MODIFICATION REPORT

Avonlie Solar Farm SSD 9031

October 2020

Project Number: 17-439

Figure 1-2: Project Layout.

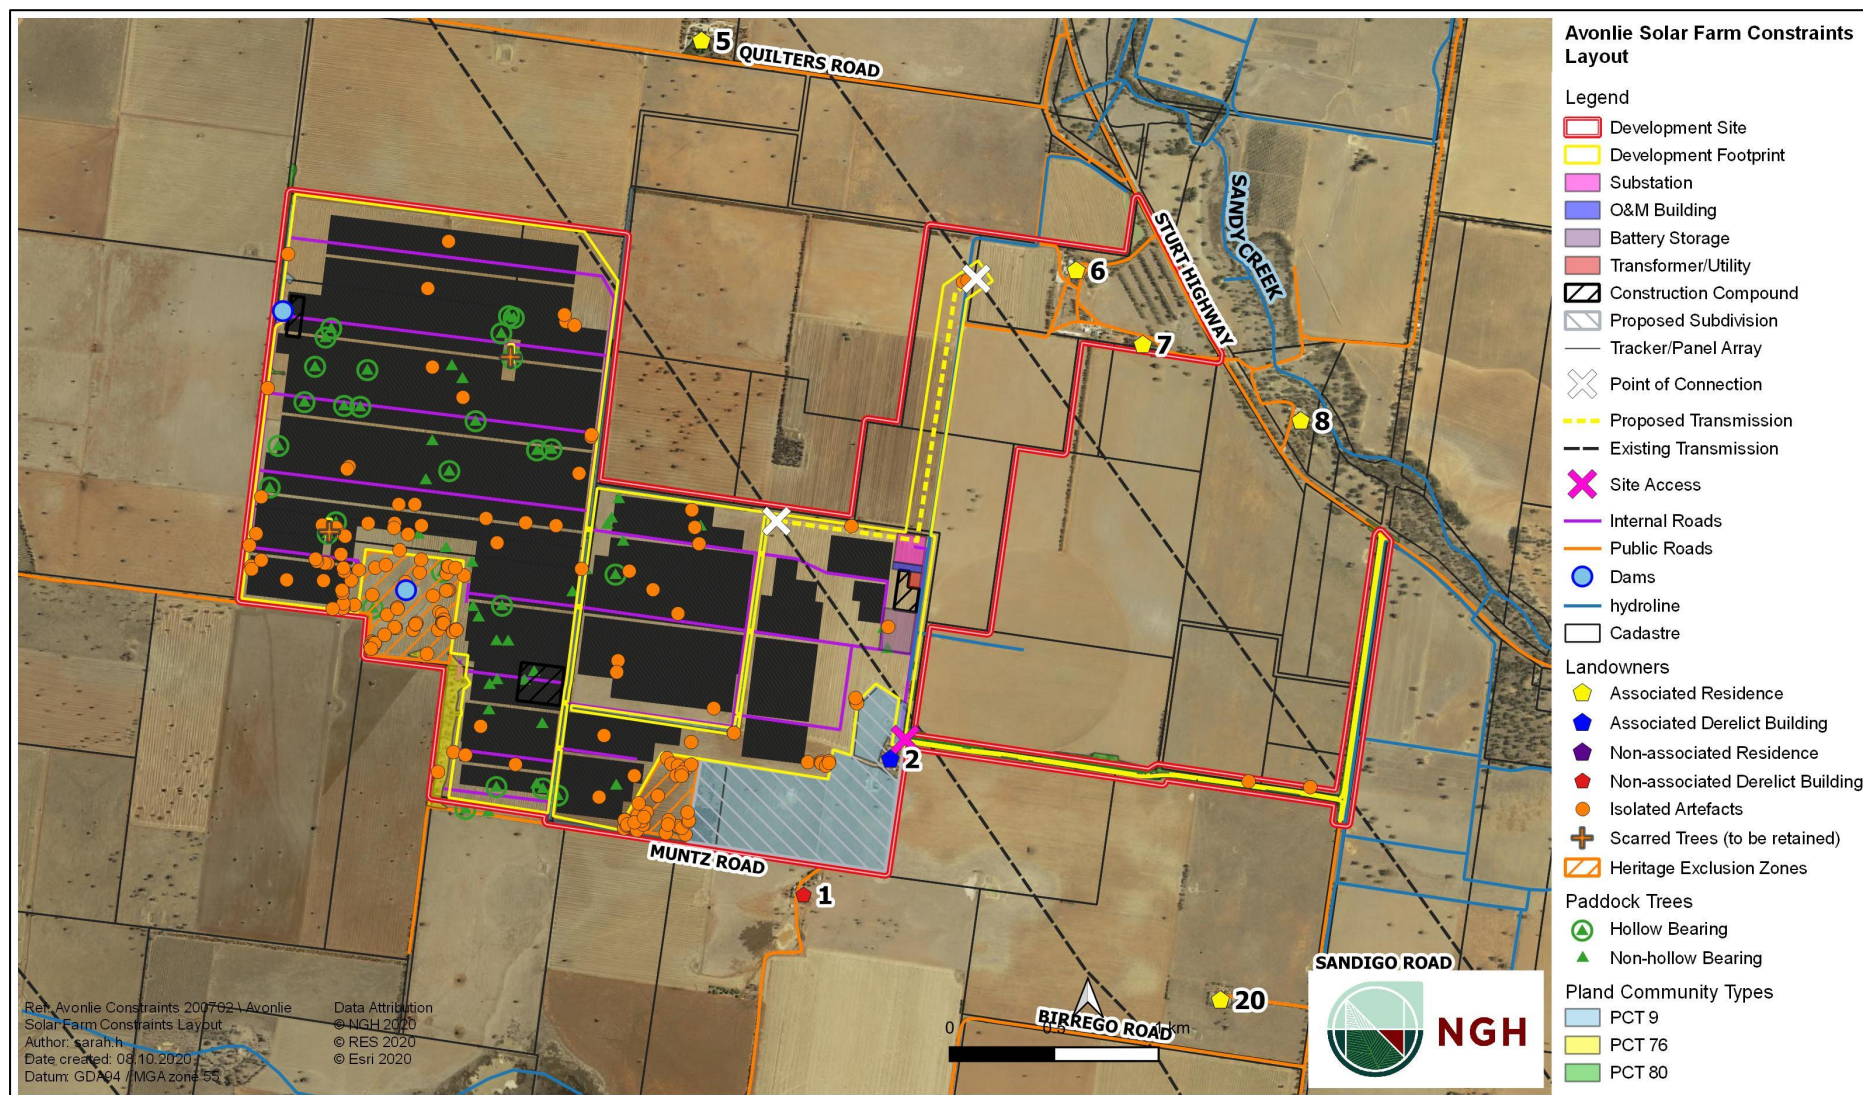
The proponent has also modified a section of the internal road layout within the development site, to allow for internal access (Figure 1-3) and electrical reticulation. NGH have applied a 7m buffer to this road design. The road width would be no more 6m wide within a 14 m wide corridor. The electrical reticulation would generally run parallel with the internal road network. A 14 m wide disturbance corridor was used to determine the maximum width of vegetation clearing to remaining within the scope identified in the BDAR.

Figure 4-1. Sandigo and Muntz Road Vegetation Impacts (Map 1).

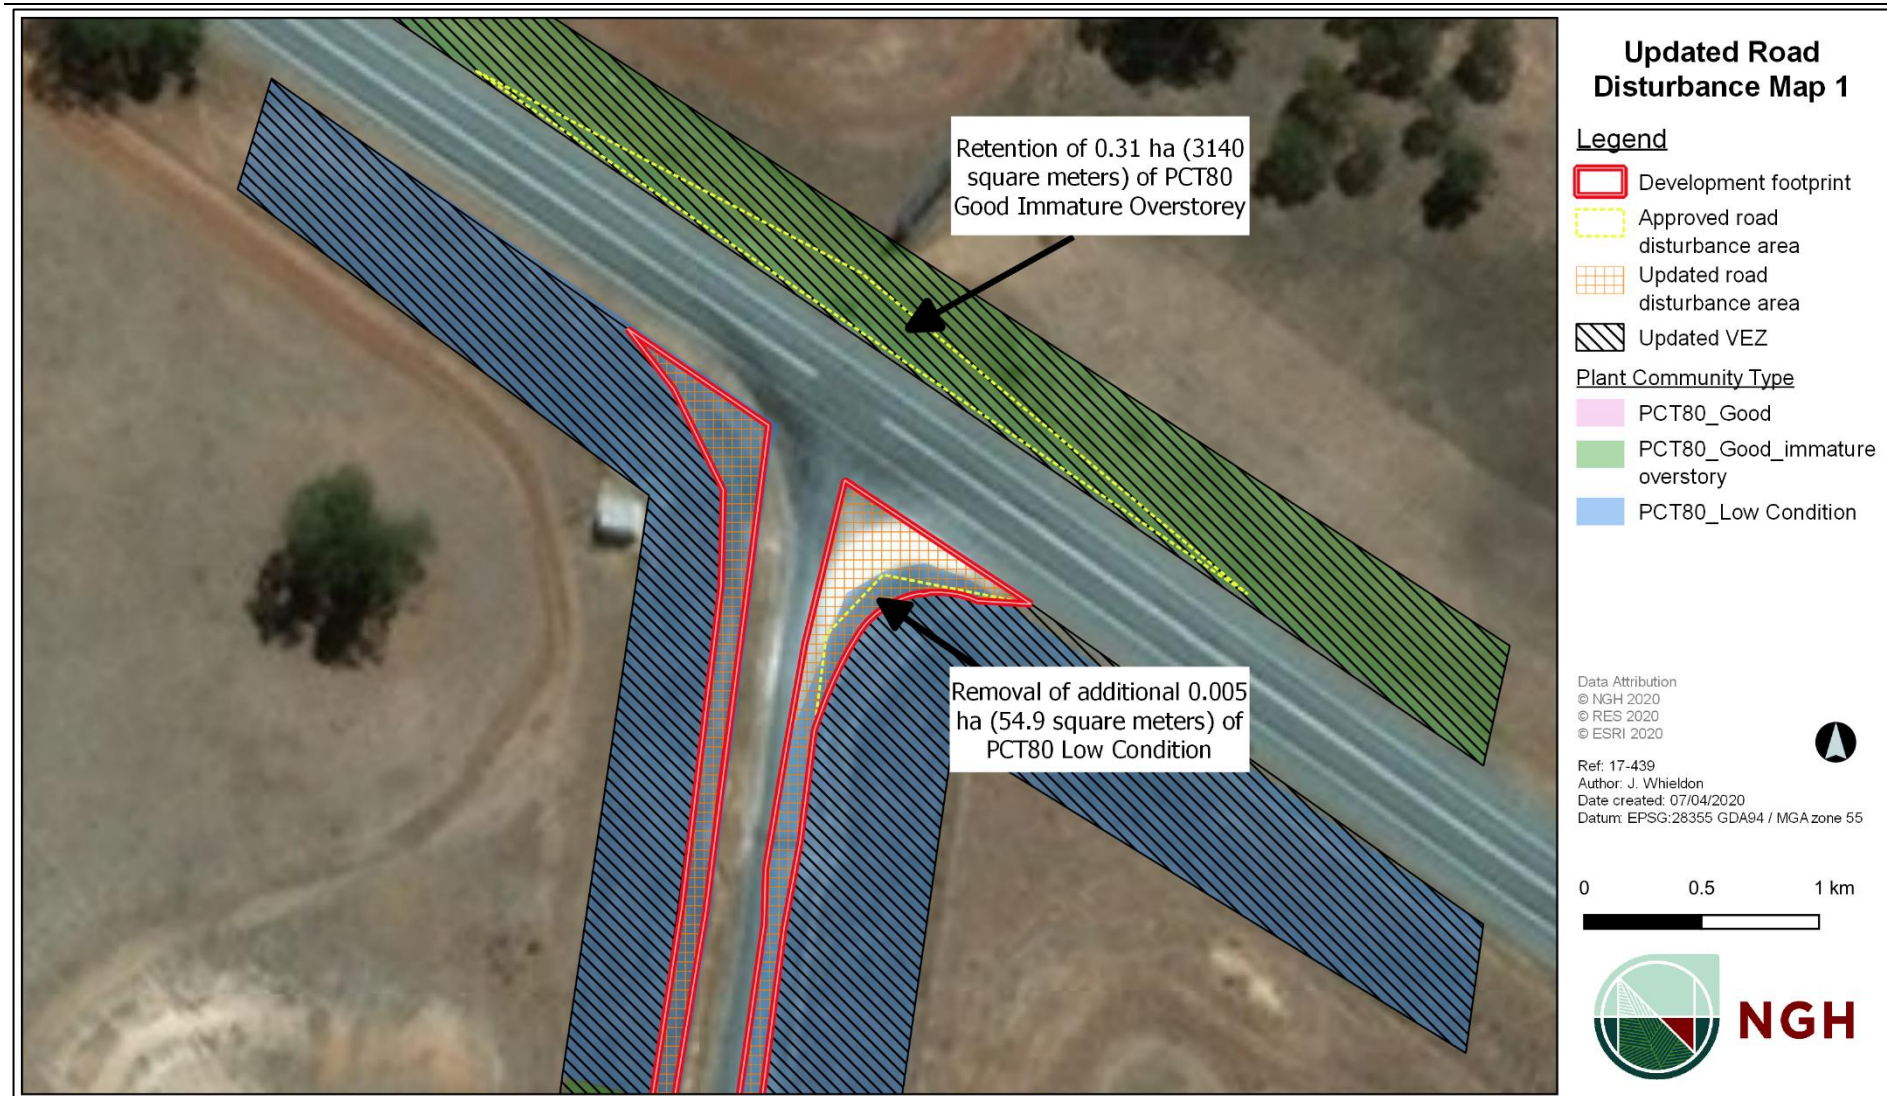
The detailed road design was constructed to maintain vegetation clearing within the scope of the BDAR. To accomplish the detailed road design disturbance footprint was reduced with vegetation exclusion areas expanded. The detailed road design has resulted in an increase in the width of clearing along some sections, particularly at the intersection of Muntz Road and Sandigo Road, and Sandigo Road and Sturt Highway. However, along other sections of Muntz Road and Sandigo Road the width of the upgrade has decreased, resulting in less disturbance (Figure 4-1; Figure 4-2; Figure 4-3). All clearing north of the Sturt Highway intersection is also no longer required. As a result of the detailed road design, an overall reduction of 0.18 ha in the total area of clearing has been achieved (Table 4-3).

Figure 4-4: Internal Road Modification Vegetation Impact (Total)

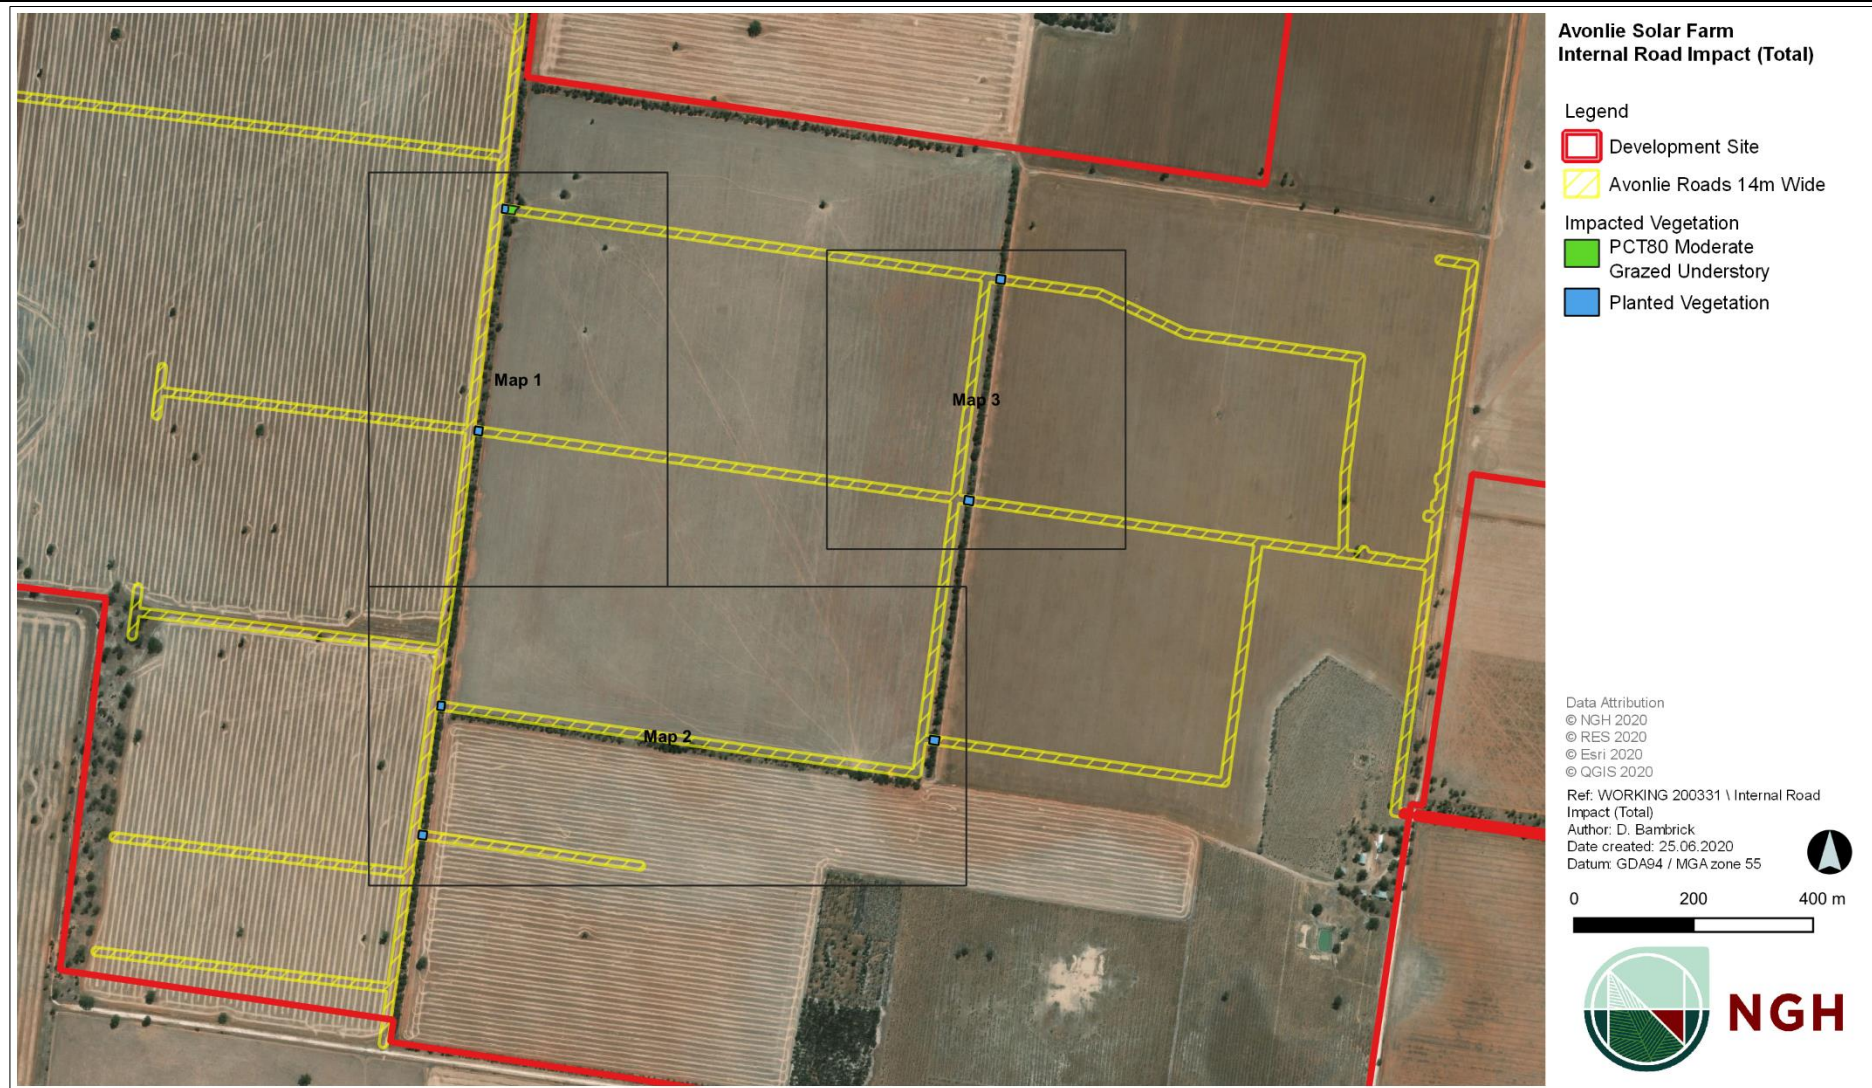
The internal road modification was designed to maintain vegetation clearing within the scope of the BDAR. To accomplish this, the internal road corridor footprint was reduced to 14m wide. Vegetation zones impacted by the internal road modification include zones 3 and 5. The internal road modification resulted in an overall increase of 0.13 ha of vegetation clearance (Table 4-4). The current offset credits have been updated to address the changes native vegetation impacts (4.3.3).

Avonlie SF Haulage Route

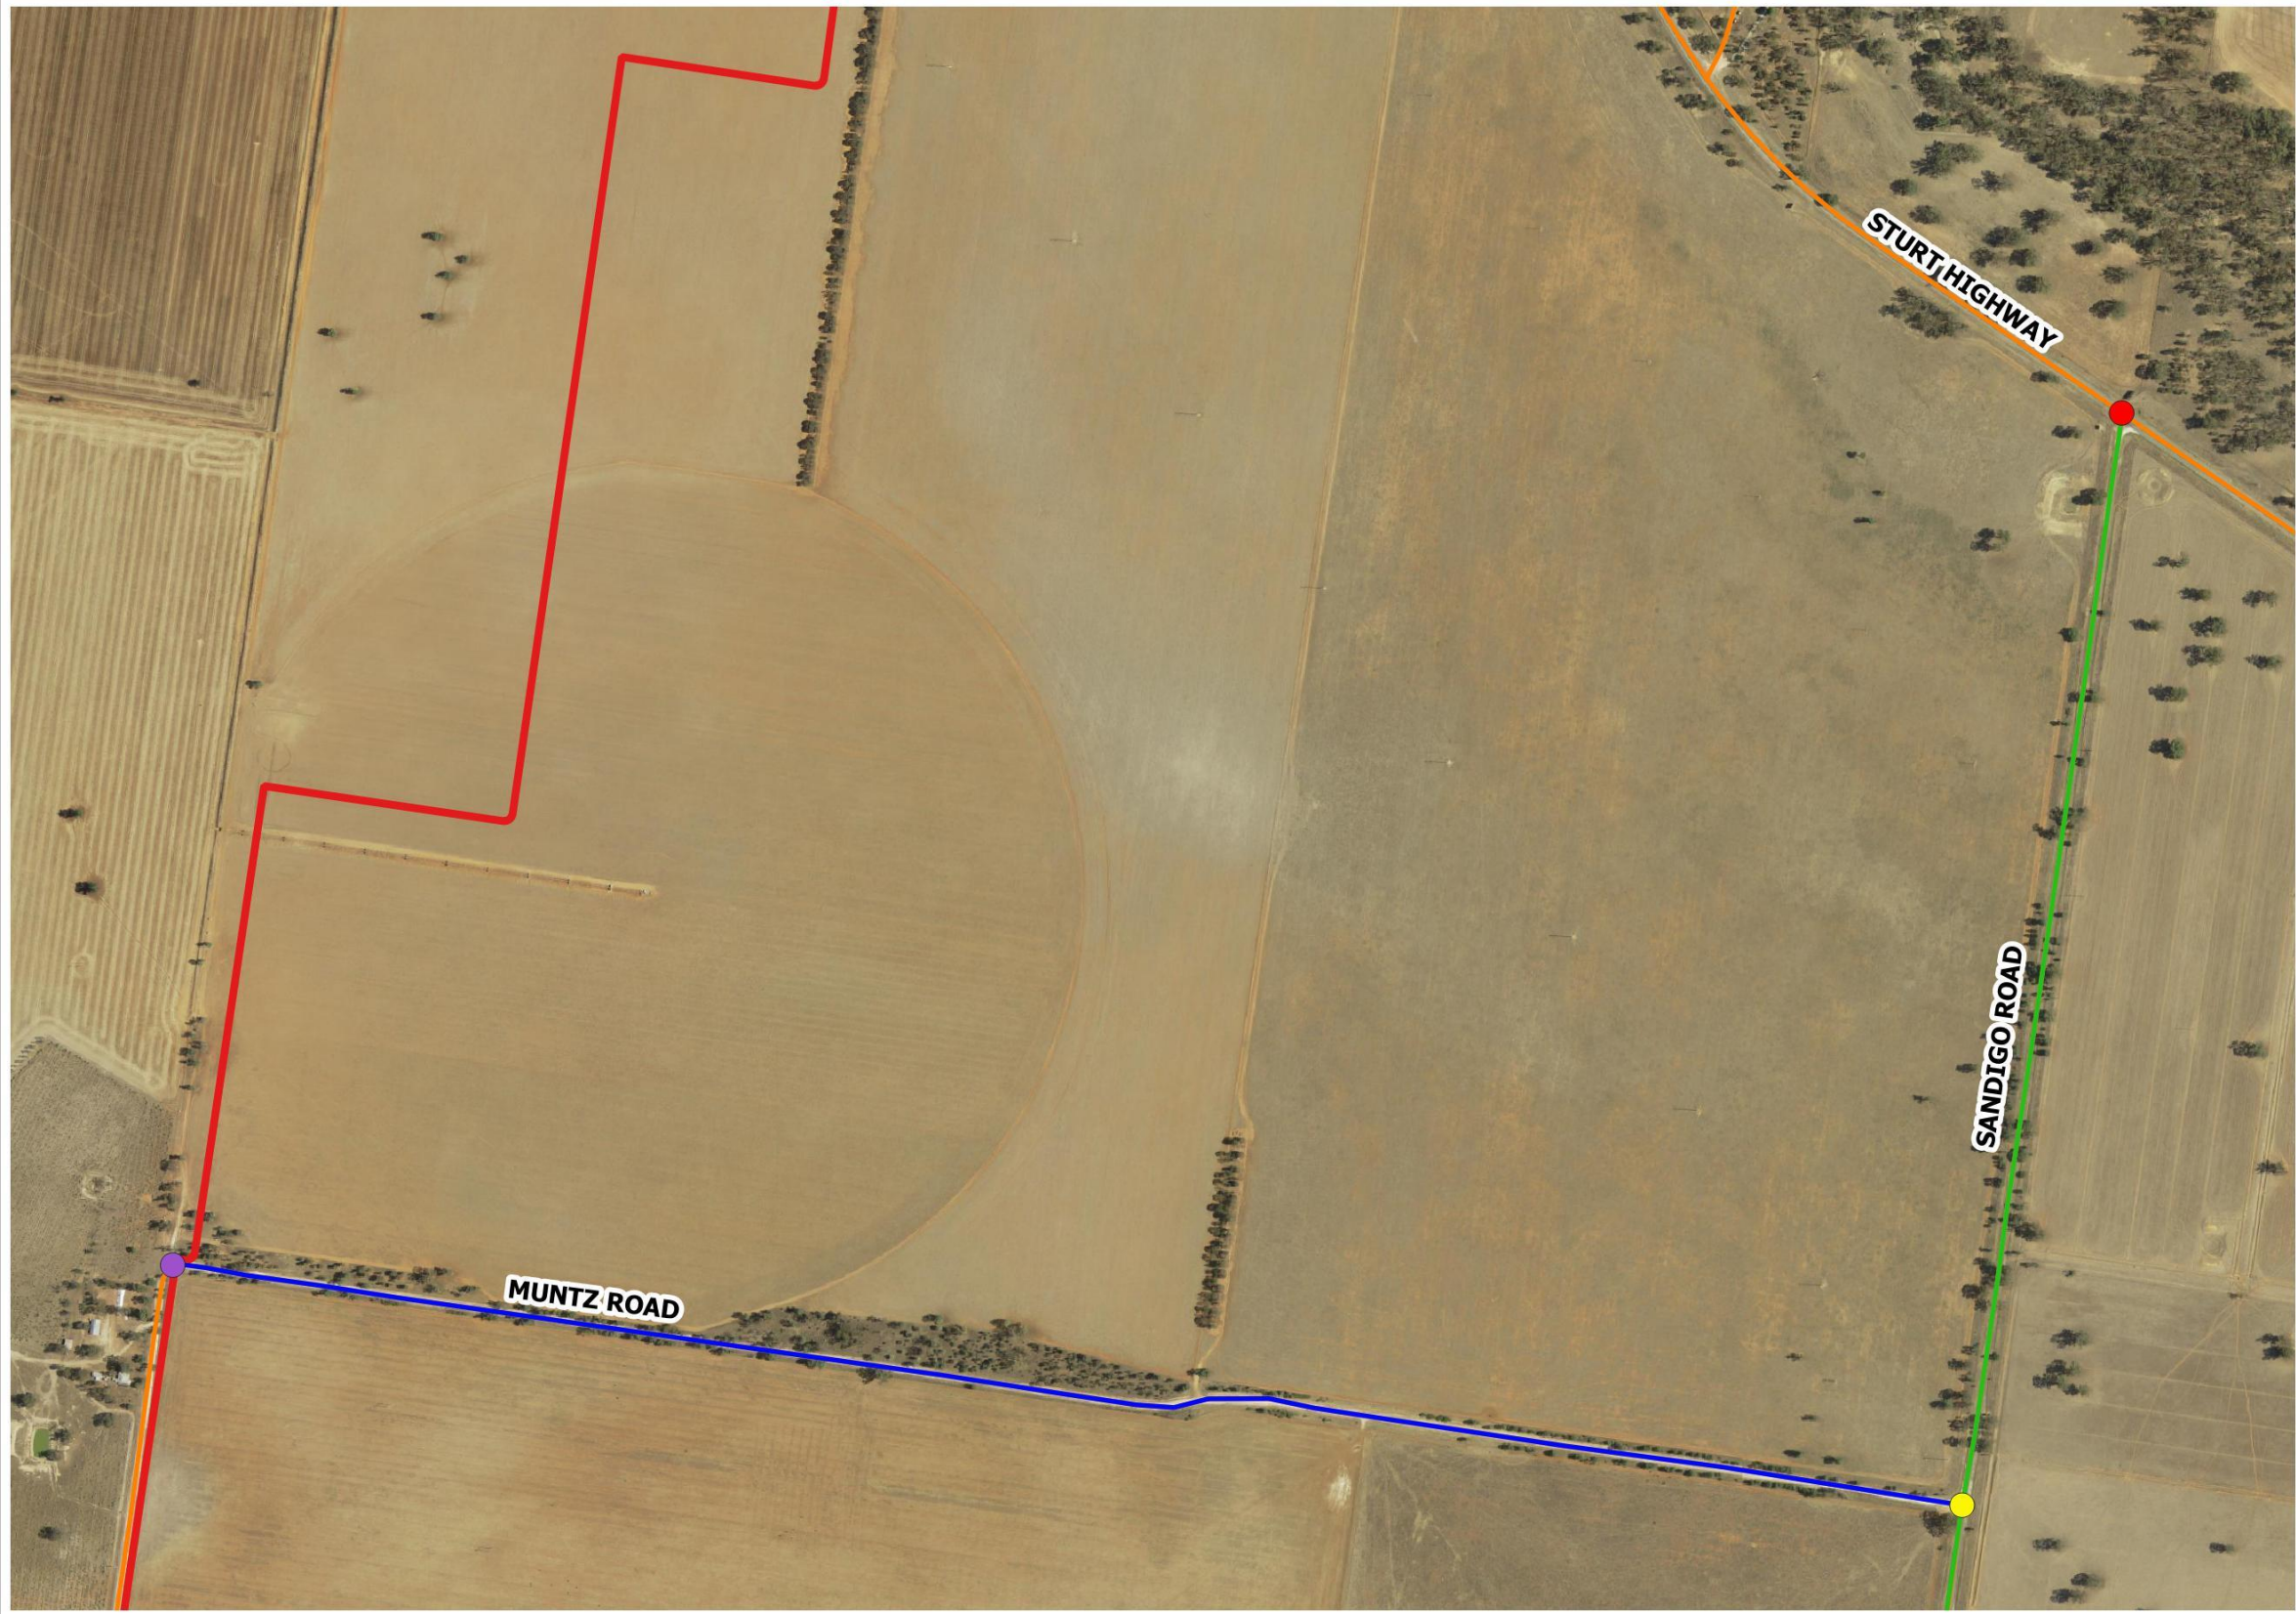
-  7m seal 1m gravel shoulder 100m past Muntz Road intersection
-  6.2m gravel upgrade 0.5m gravel shoulder
-  Public Roads
